Trumbull County Board of Health – Special Meeting
August 9, 2021 – 6:00 PM
Hubbard City Council Chambers
220 W. Liberty St. * Hubbard, Ohio 44425

RE: Technical Review Comments for
Trans Rail America C&DD License Application
Hubbard Township, Trumbull County, Ohio

OAC & Technical Review Comments

TRANS RAIL AMERICA, INC.
CONSTRUCTION AND DEMOLITION
DEBRIS FACILITY
CROSS SECTION PLAN

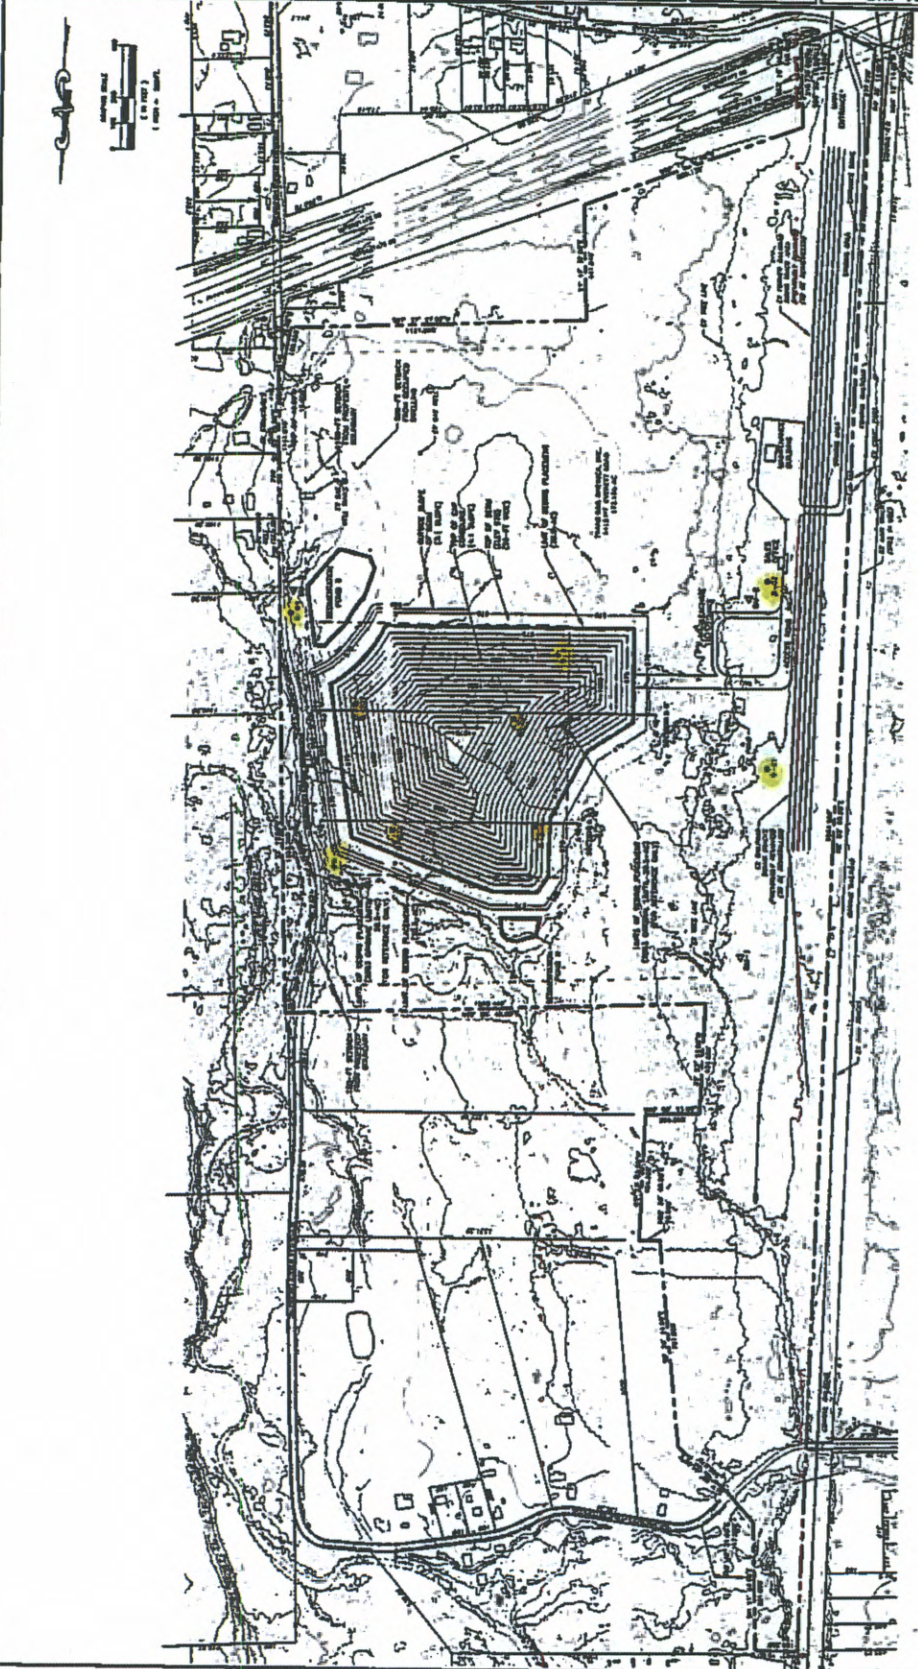
OAC 3745-400-09(C)(5) contains information for collecting specific data used in the hydrogeologic investigation to support the ground water scientist's report. The investigation shall be documented in a narrative report using such maps and cross sections as to clearly convey the nature of the hydrogeology beneath the facility. Test boring logs, laboratory testing data, maps and cross sections were prepared and presented to better understand the hydrogeology. Nine (9) test bores were performed at the site ranged in depth from 30 feet to 49 feet. The table below and attached sheet 4a shows a general summary of the test bore depths and locations:

Within the Site Characterization Report, the ground water scientist stated that *"the upper perched zone does not meet the definition of an aquifer system."* It is unclear how that statement could be made because according to OAC 3745-400-01(C), the following three criteria are necessary: (1) *yields less than three gallons per minute but greater than one-tenth of a gallon per minute.* (2) *The ground water yield is less than fifty percent of the yield of another saturated zone present under the facility.* (3) *Which is the likely source of water used for any purpose within one mile of the facility.* The applicant has not drilled to another saturated zone within the bedrock beneath the facility or demonstrated that the yield of the two-inch test well is comparable to the nearby residential wells of a larger diameter.

The ground water scientist went on to say that *"The upper-most aquifer system which, based upon the data from ODNR, is located within the underlying bedrock material at an approximate depth of 60 to 80 feet"*. According to OAC 3745-400-09(C)(5)(c) which states, *"when ground water monitoring is required for a facility, a description and documentation of the first continuous significant zone of saturation underlying the facility. This description and documentation shall include the depth to the lateral and vertical extent of the first continuous significant zone of saturation underlying the facility."* The nine (9) test bores completed at the Trans Rail site were not drilled deep enough to determine the actual upper-most aquifer elevation or accurately characterize the geology beneath the proposed landfill. The upper-most aquifer elevation was assumed and not confirmed. This data showing the top of the uppermost aquifer system must also be shown on the cross sections [OAC 3745-400-07(F)(4)(b)].

The uppermost aquifer and the hydrogeology beneath the facility is not clearly defined. The 5-foot isolation distance beneath the bottom of landfill debris and the uppermost aquifer have to be further reviewed and confirmed. When questioned in a previous review comment about the upper aquifer and perched zone, no detail response was received. It remains a valid and unanswered question. Furthermore, without a clearly defined hydrogeology beneath the facility, procedures for collection of representative samples for the ground water monitoring are not adequately defined. A final summary as to whether the standards established in rule 3745-400-06 was not provided.

Ground Water Resources of TRUMBULL COUNTY

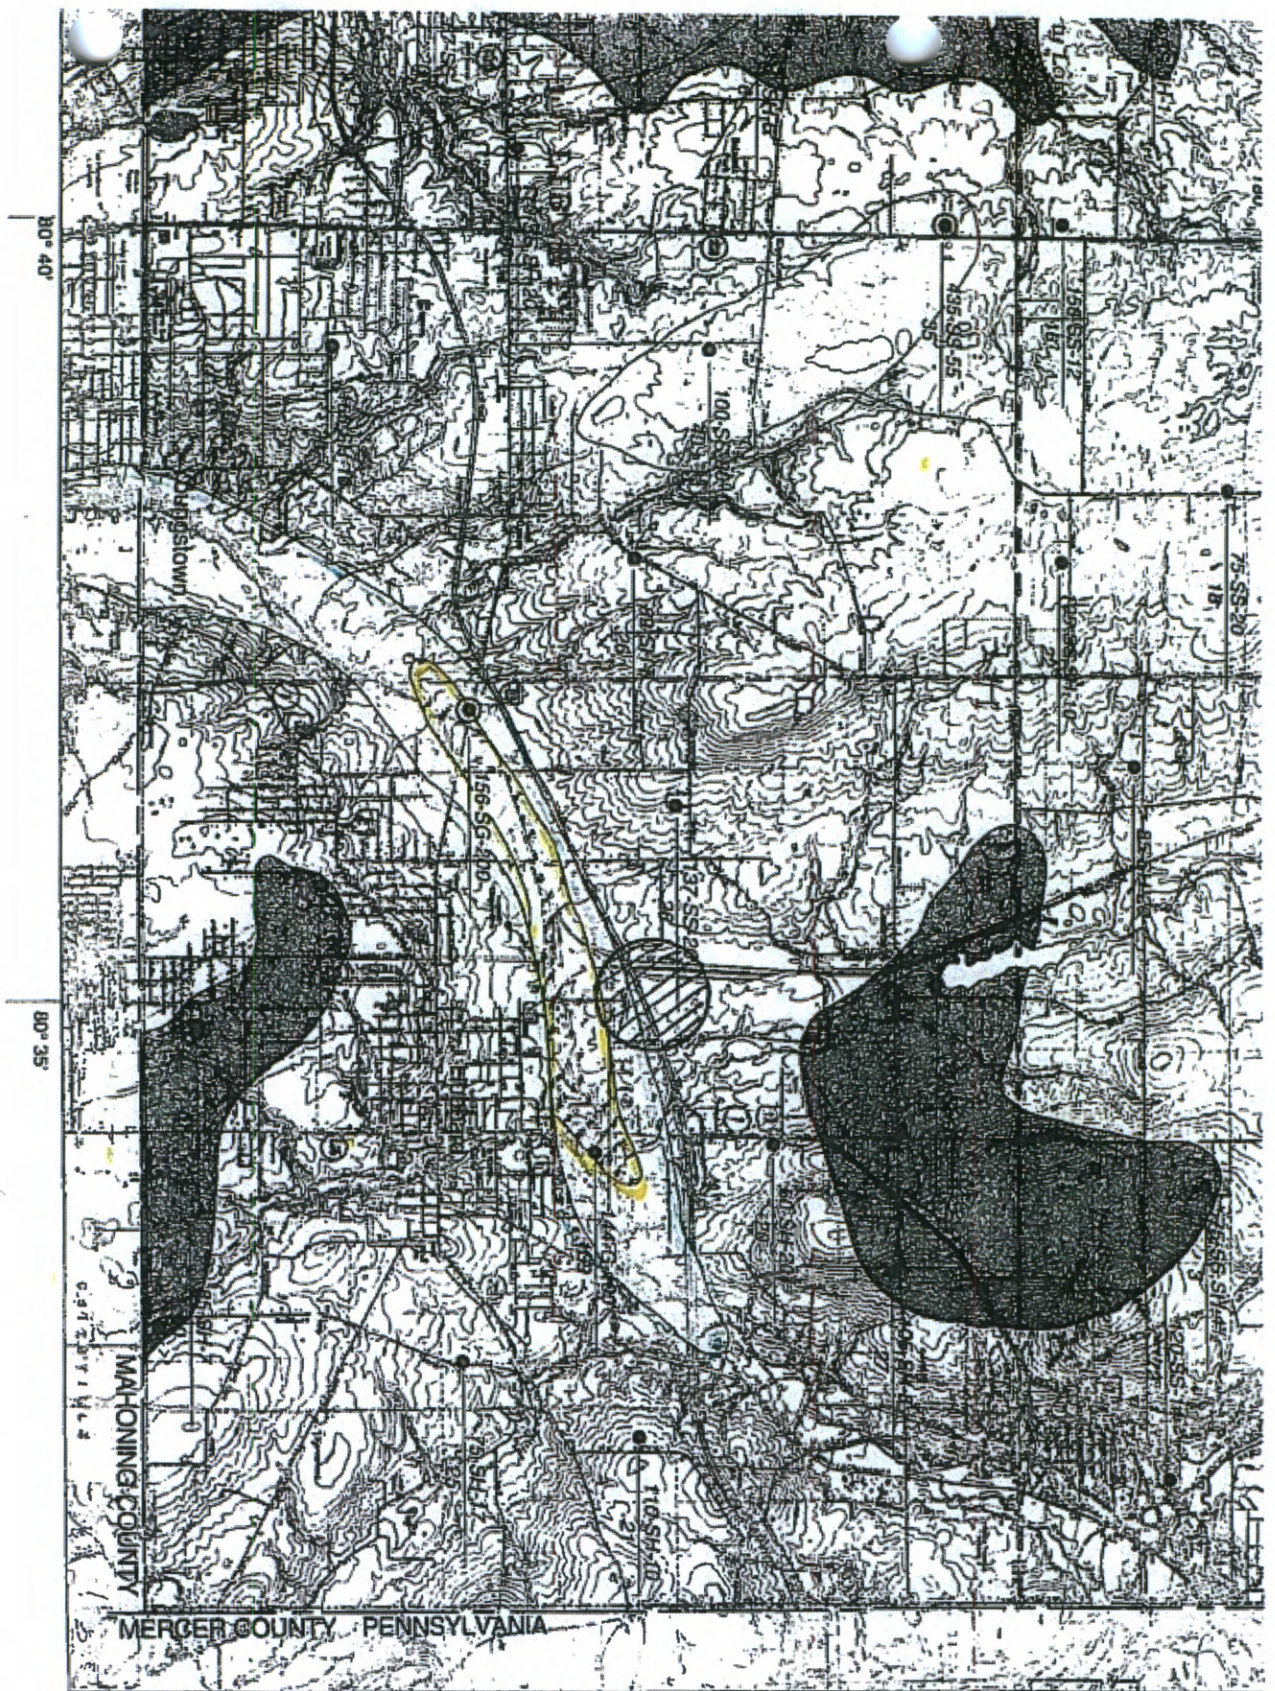
Additional Comment: The proposed location of the landfill is in close proximity to a major underground water aquifer (Haiker 1979) and several abandoned mines which were constructed during the late 1800's (Reference attached information). The general history of the surrounding mines and effects on the aquifer system should be reflected in the narrative along with possible actions if unforeseen conditions occur.

IRREVOCABLE STANDBY LETTER OF CREDIT NUMBER: 3078589

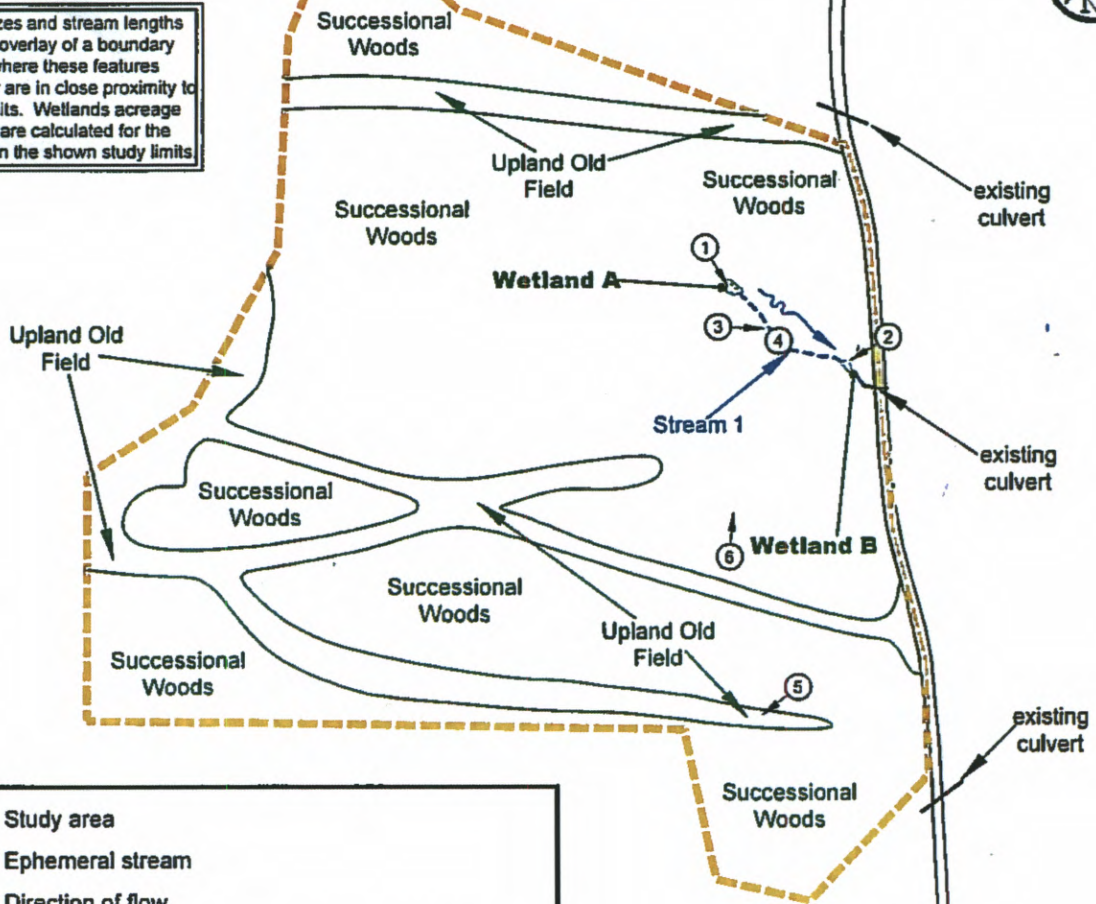
OAC 3745-37-02(E)(6) All financial assurance documentation required by Rule 3745-400-13 of the Administrative Code shall be included with a C&DD license application. Trans Rail America provided an irrevocable letter of credit (#3078589) dated November 23, 2005 which was not to exceed \$75,875.00 and contained an expiration date of January 2, 2007 with an annual extension (Reference attachment). The original application was Trans Rail America, Inc. Capitol Heights, MD. The Trumbull County Recorder's office shows a quit-claim deed from Trans Rail America to RBS-Ohio, LLC dated June 22, 2012. The status of Trans Rail America in the jurisdiction of Maryland was listed as forfeited. For domestic corporations, this also means that the business has no existence under the laws of the State of Maryland. The financial assurance documents, calculation worksheets, letter of credit, and environmental covenants (if necessary) need revised accordingly and submitted. Signatures and title of officials issuing institution with date should be a part of the document.

Appendix B Plant Communities Map

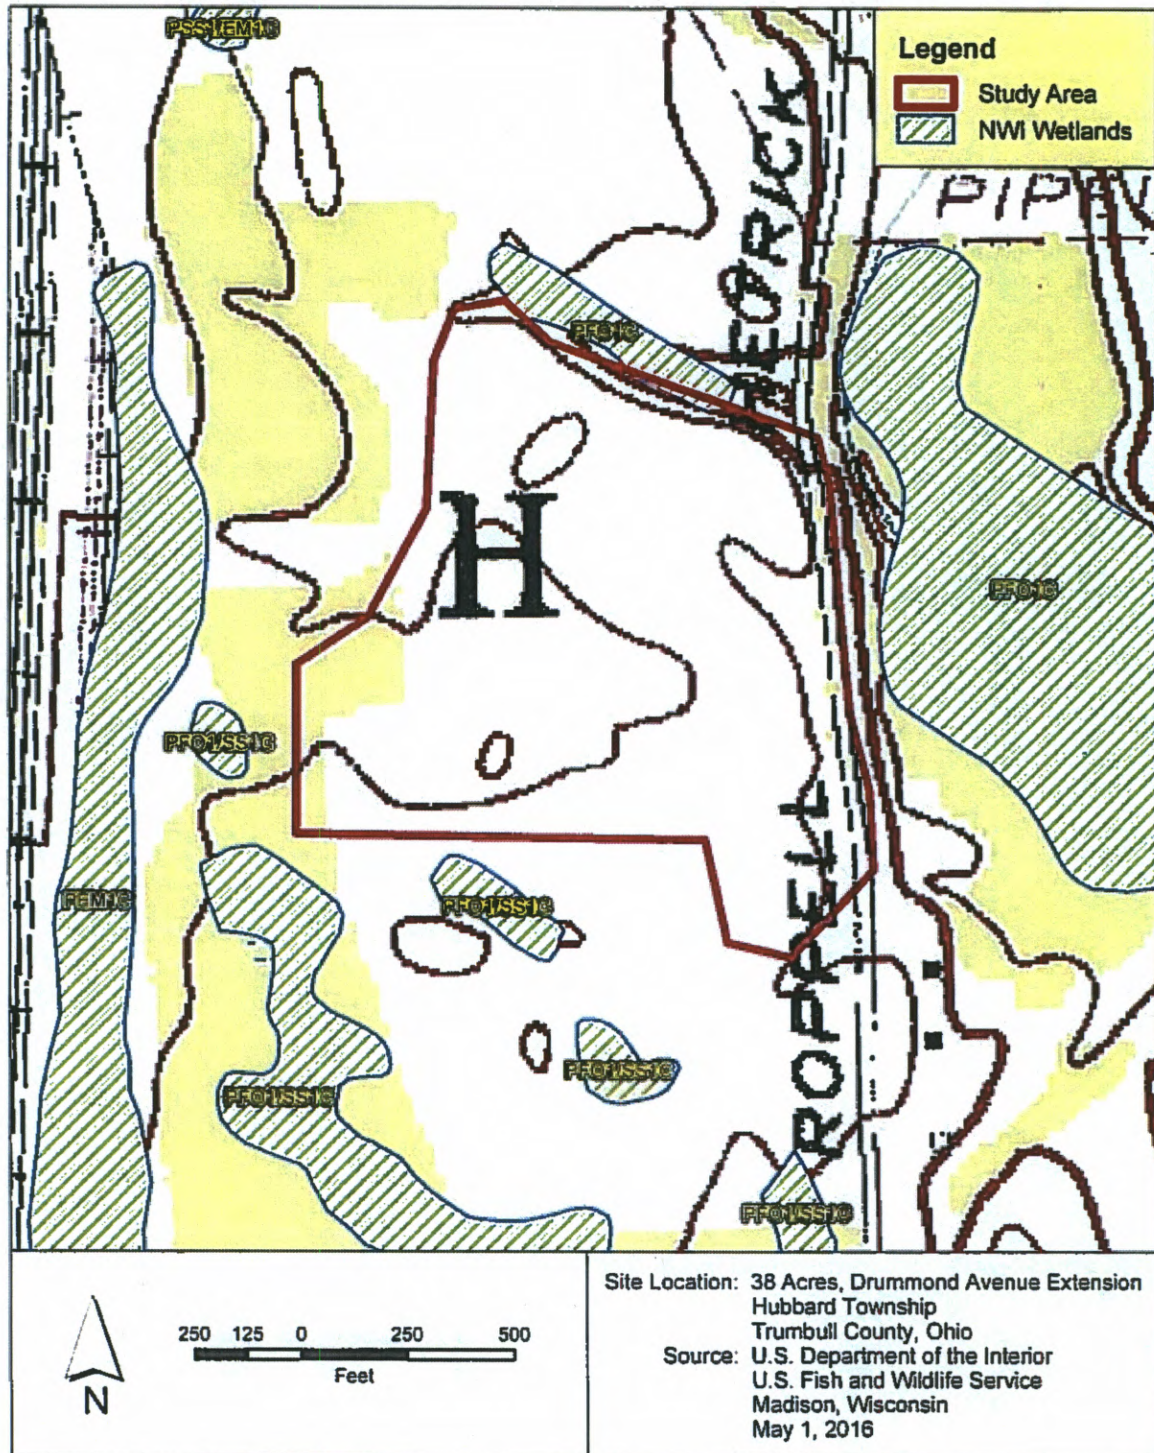
The Trans Rail America property contains 172.186 acres of land. In September 2016, Davey Resource Group provided a wetland delineation report of 38 acres which will be within the vicinity of the limit of debris. The delineation report listed two wetlands totaling 0.019 acres and 230 L.F. of an ephemeral stream (flows only briefly during and following a period of rainfall in the immediate locality) would be impacted. No category 3 wetlands were listed. The Army Corp of Engineers issued a pre-jurisdictional determination letter concurring with the wetlands shown in the September 26, 2016 report. This report did not involve

other areas within the Trans Rail site or the impacts of construction. For example, the 20.5 acre debris area will be excavated 30 to 40 feet deep beneath the existing ground surface. This would amount to 1 to 1.3 million cubic yards of excavated material. The debris placement plan did not provide environmental impacts resulting from stockpiling and hauling the excavated materials, borrow pits, cover material (including weekly fire protection) or temporary roads. The specific on-site and/or off-site locations of where the material came from has to be shown in relationship to the wetlands and streams. Based upon the enclosed copy of the national wetlands inventory map which was part of the 2016 delineation, pockets of wetlands and waterways surround the 38-acre study area. The report did not incorporate impacts to wetlands or streams on the entire 172.186 acre parcel. OAC 3745-400-01(G) states "*For the purpose of siting a new construction and demolition debris facility, Rule 3745-400-06 of the Administrative Code requires that the entire facility, not merely the limits of construction and demolition debris placement, be located in areas not prohibited by statute.*" The report was limited and did not comment on disturbances beyond the 38 acre study area. The environmental impact due to construction is likely beyond 0.019 acres and 230 L.F. of stream as stated in the wetland delineation report. Future permits will be required prior to construction, but the debris placement plan lacked sufficient information.

TRANS RAIL AMERICA, INC.
CONSTRUCTION AND DEMOLITION
DERRIS FACILITY
GRADING
FINAL CAP CONFIGURATION

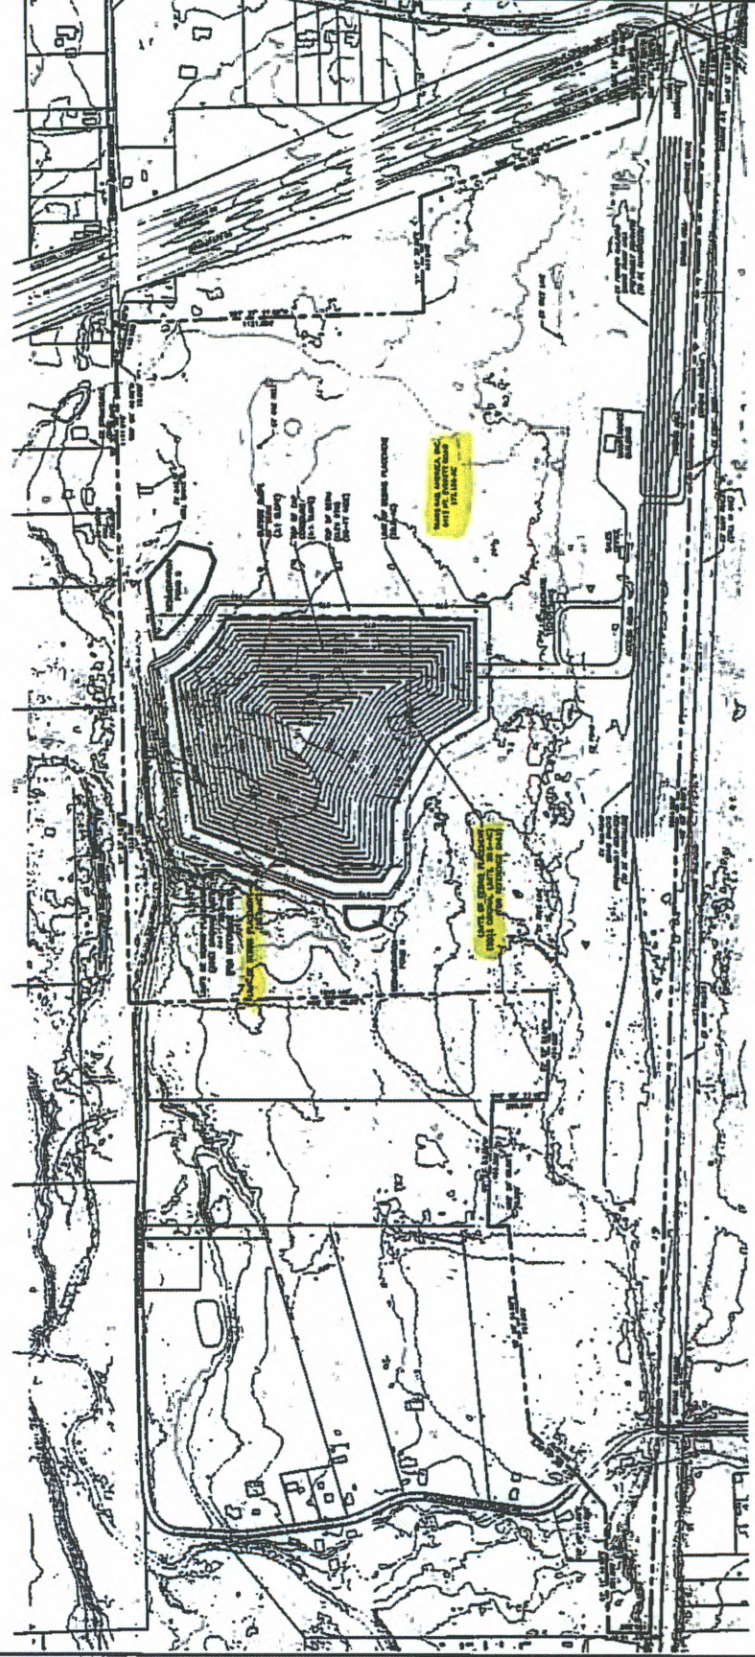
In the 2004 permit application, CT Consultants submitted drawings showing calculations for the volume of debris, anticipated life of the facility, and cap erosion. The calculated data was based upon a design different than the Buckeye Civil Design plan. The total limits of debris remained at 20.5 acres, but the debris area footprint, depth, bottom slope and location were all changed. The calculations submitted by CT Consultants do not reflect the revised plan provided by Buckeye Civil Design. No revised set of calculations with an engineer's seal from Buckeye Civil Designed were provided. The design calculations with references to equations, site specific input and assumptions shall be signed by an engineer and in accordance with OAC 3745-400-07(F)(6) and OAC 3745-37-02(E)(5).
